Public Broadcast Profile

Bluetooth® Profile Specification

- **RevisionVersion:** ~~v1.0~~v1.0.1
- **RevisionVersion Date:** ~~2022-07-05~~2024-10-01
- **Prepared By:** Audio, Telephony, and Automotive Working Group

This document is provided as a courtesy to help readers identify changes between two versions of a Bluetooth specification. When implementing specifications, use the adopted versions located at www.bluetooth.com.

Figure 2.1: Public Broadcast Profile hierarchy

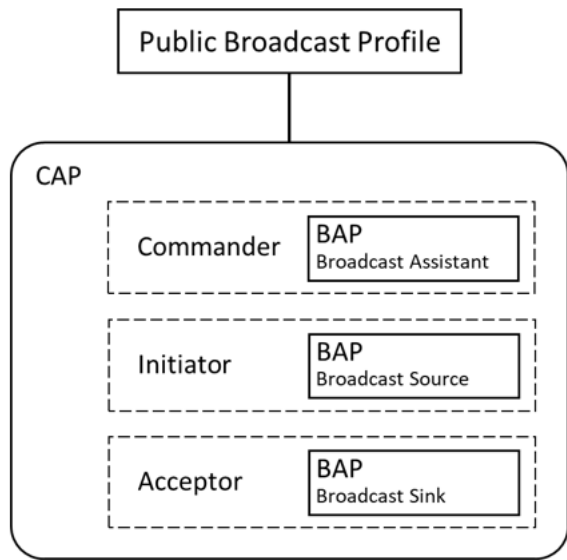
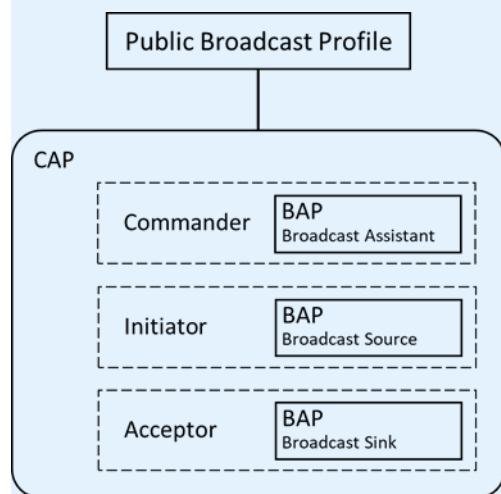
~~This profile uses procedures defined in CAP [4] for broadcast Audio Streams. As shown in Figure 1.1, this profile extends only the Broadcast part of CAP.~~

This profile uses procedures defined in CAP [4] for broadcast Audio Streams. As shown in Figure 2.1 , this profile extends only the Broadcast part of CAP.
